3GPP TSG RAN Meeting #27 **RP-050041**
Tokyo, Japan, 9 - 11 March 2005

Title **CRs (Rel-6) to 25.101, 25.133, 25.141, 25.942 under WI Small Technical Enhancements and Improvements Rel-6**
Source **3GPP TSG RAN WG4 (Radio)**
Agenda Item **9.8**

Figure A.xz (Informative): Channel coding of DL reference measurement channel 2 (64 kbps)

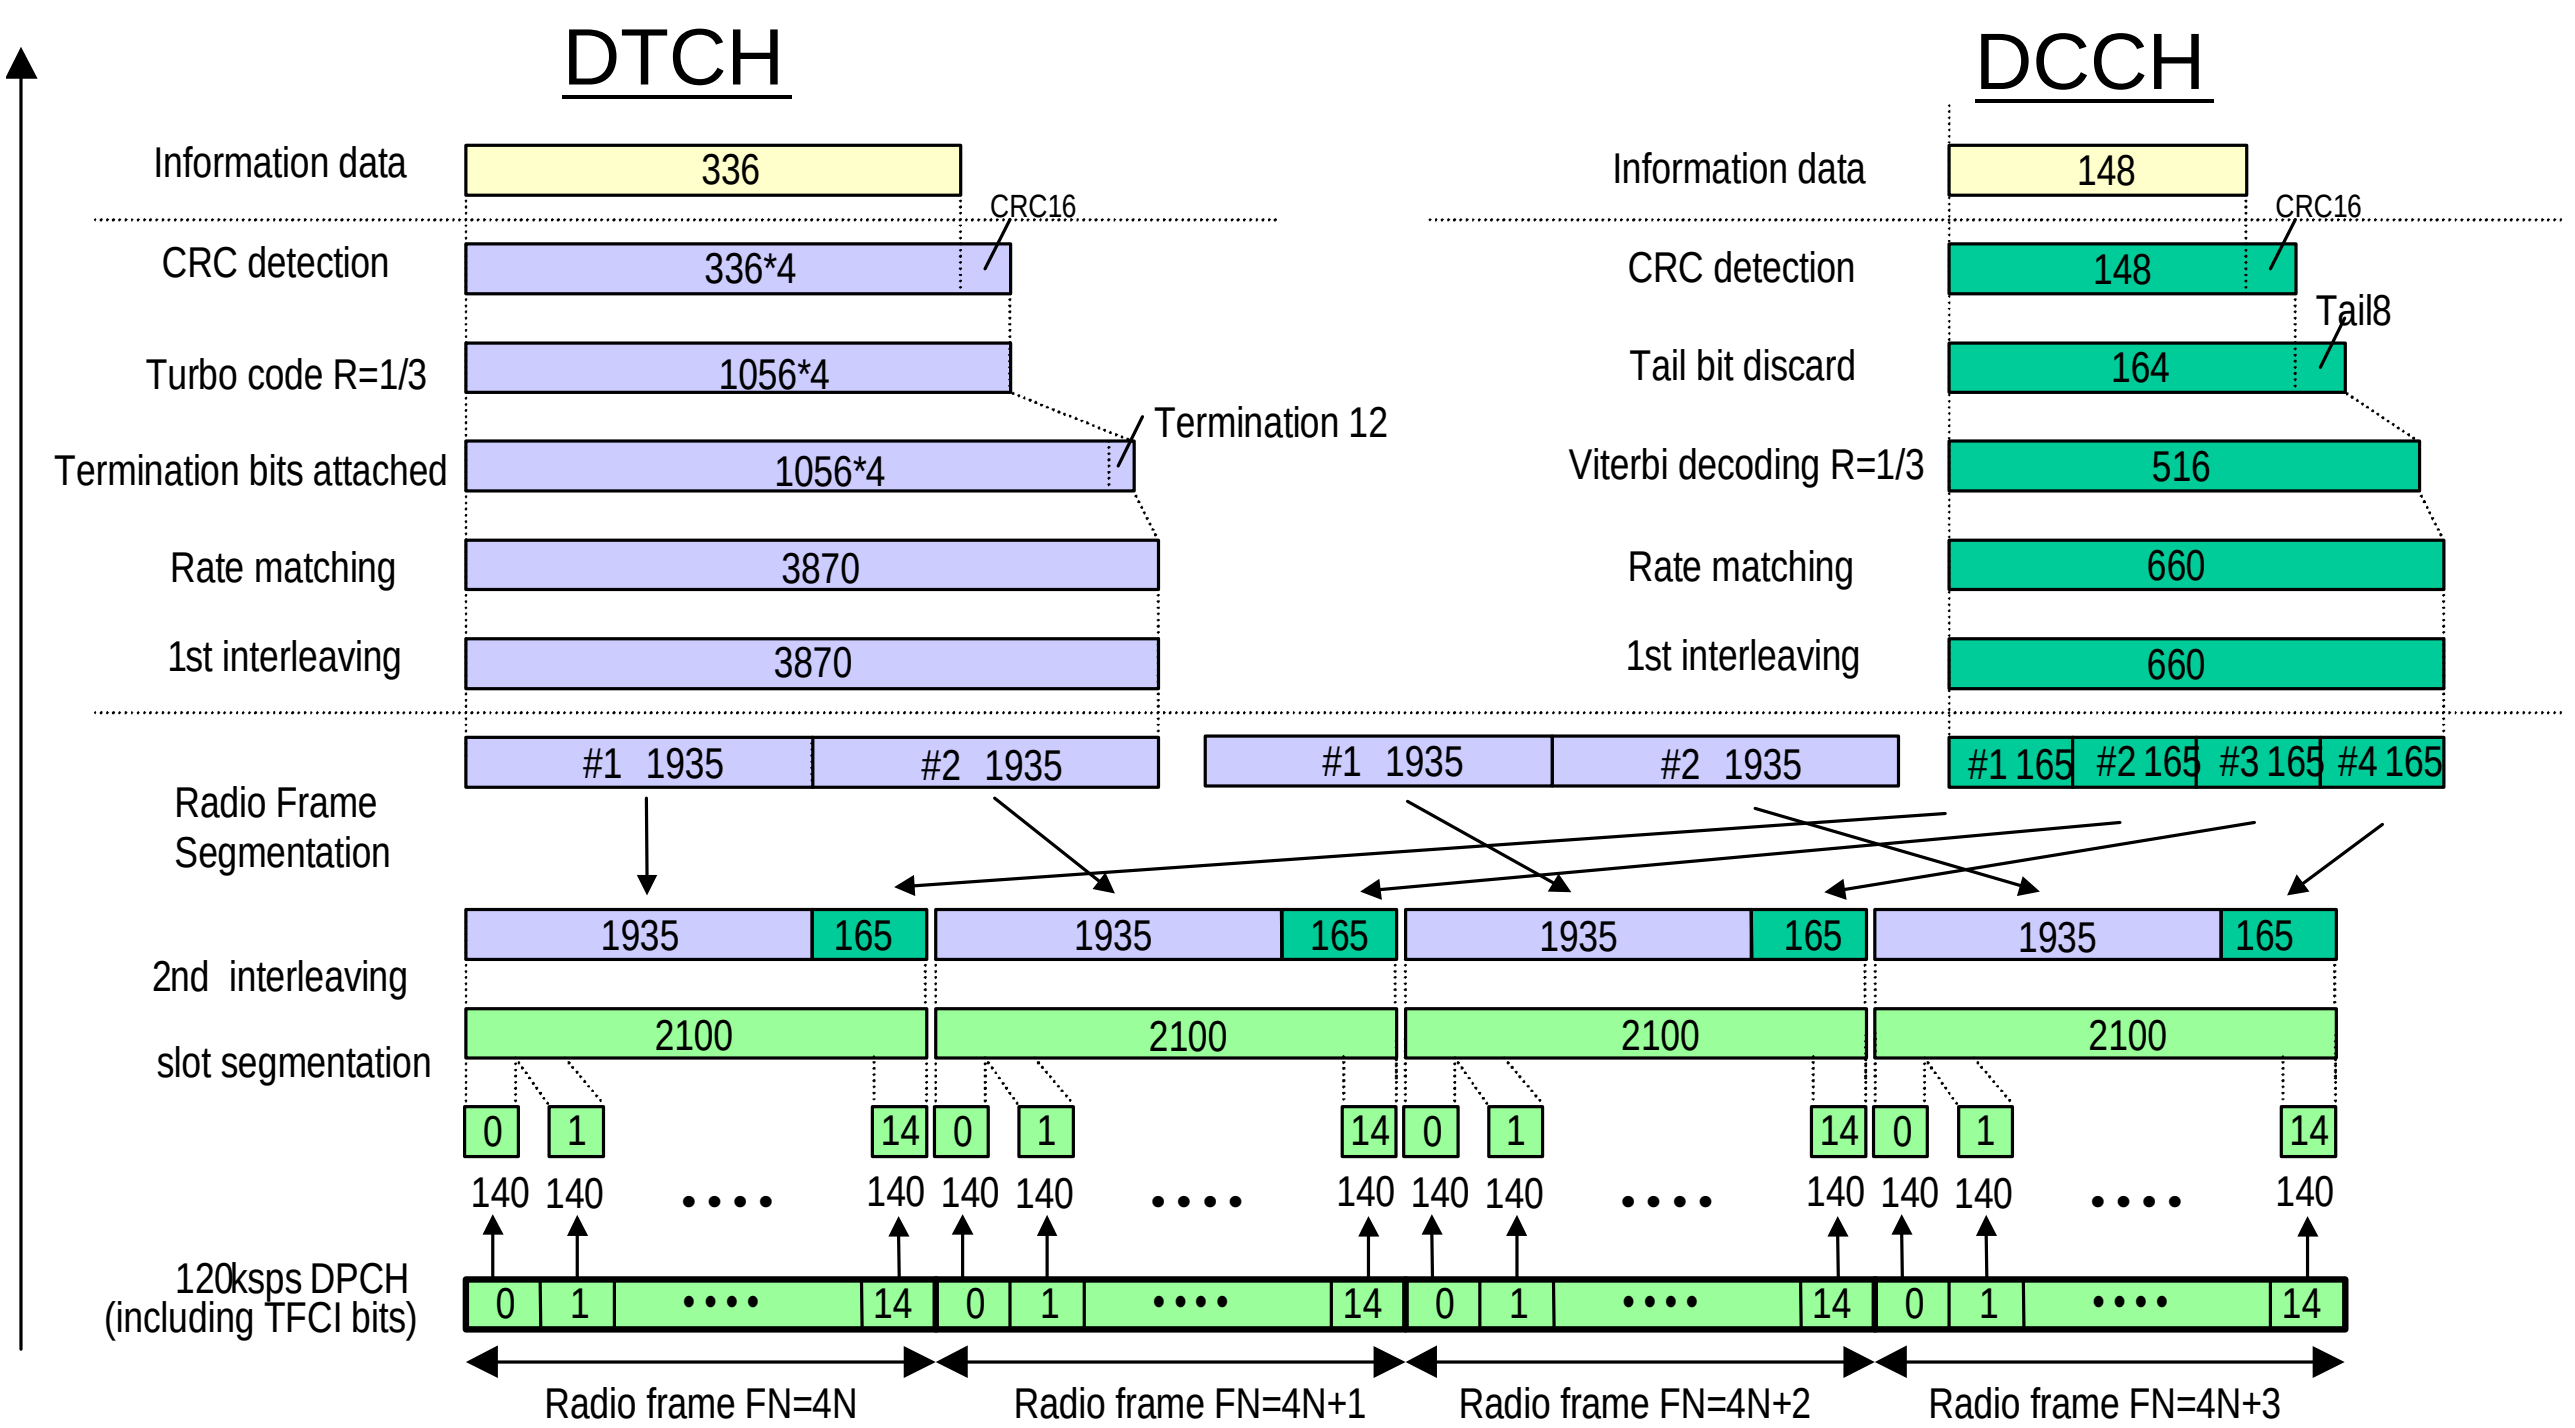
Reason for change: ⌘	- To define downlink power control test cases with constant BLER. - To define new reference measurement channel, which is to be used for the new test cases for the UE performance.
Summary of change: ⌘	Two new downlink power control test cases are defined: - Test 3 is defined to test the outerloop power control in the UE at high BLER target (10%). The BLER target of 10% is set on both DTCH and DCCH as the test parameters in table 8.29. The test requirements are specified in table 8.30 in terms of DPCH_Ec/Ior (-9.2 dB) and quality measurement (BLER) on DTCH. The accuracy of the DTCH quality measurement is specified as ± 30%. - Test 4 is defined to test the outerloop power control in the UE at low BLER target (0.1%). The DCCH and DTCH BLER targets are set at 10% and 0.1% respectively, as the test parameters in table 8.29. The test requirements are specified in table 8.30 in terms of DPCH_Ec/Ior (-10.4 dB) and quality measurement (BLER) on DTCH. The accuracy of the DTCH quality measurement is specified as ± 30%. - In both tests a new reference measurement channel (64 kbps) is used in which the DTCH has 4 transport blocks per TTI. The DCCH has an information rate of 3.4 kbps, with one transport block per TTI. - Currently all the downlink reference measurement channels (12.2 kbps, 64 kbps, 144 kbps and 384 kbps) used in annex A.3 for the UE performance contain one transport block per TTI. But in real network operation, a transport channel may have several transport blocks in a TTI, which has an impact on the UE outer loop power control behaviour.

The parameters for the DL reference measurement channel for 64 kbps are specified in Table A.yy and Table A.zz. The channel coding is shown for information in Figure A.xz.

Figure 4.2: Possible collocated MS scenarios

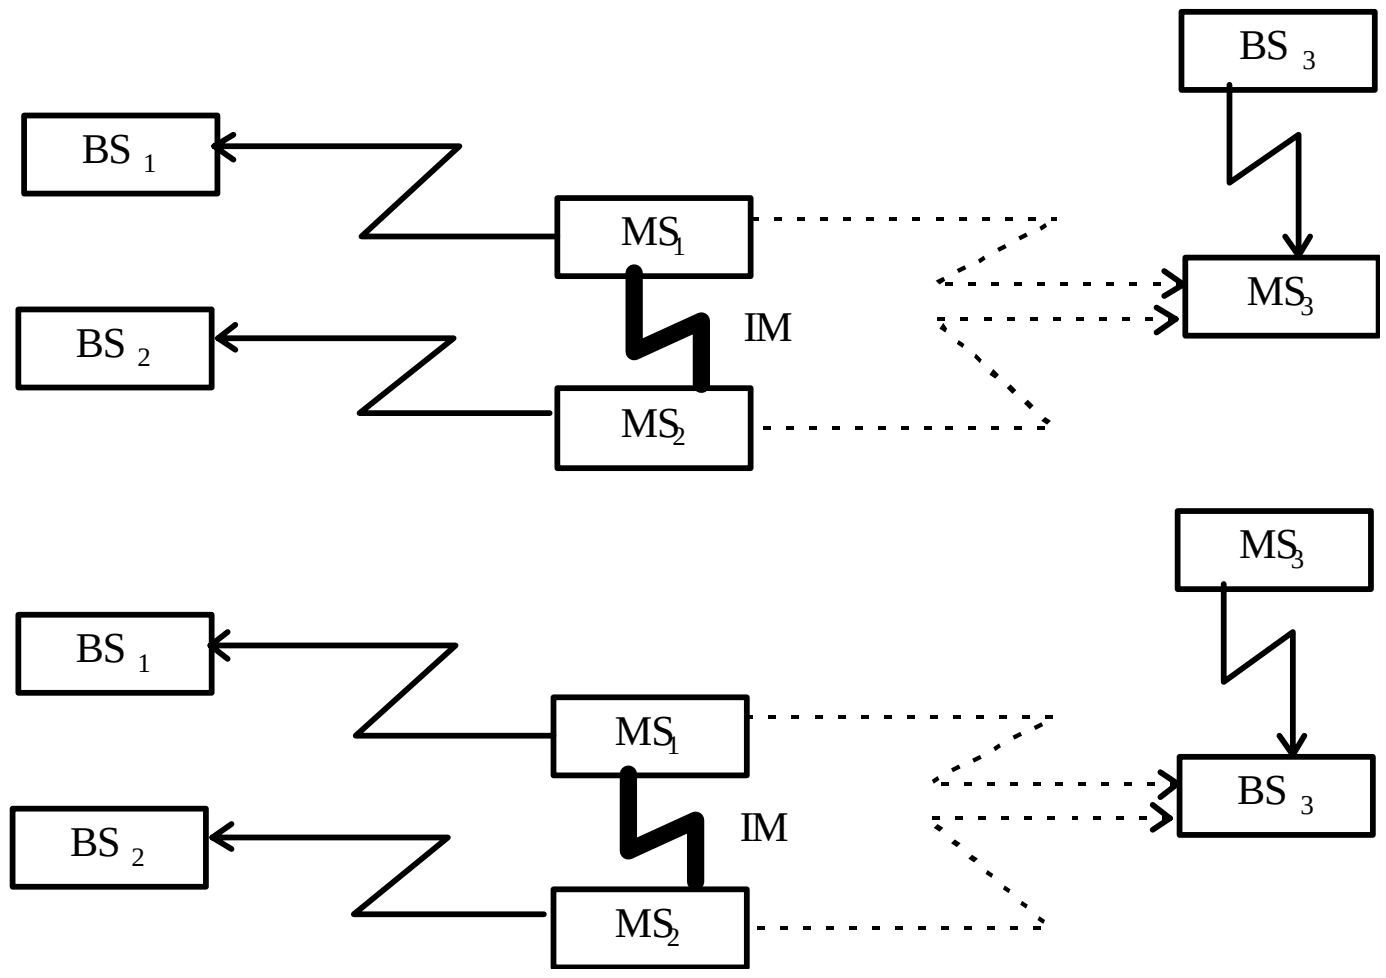
Reason for change:	⌘	Update for Band 2 and Band 5.
Summary of change:	⌘	Include scenarios for estimating UE Rx blocking due to UE to UE interference
Consequences if not approved:	⌘	Needed for analyzing potential interference threats and evaluating UMTS receiver performance.
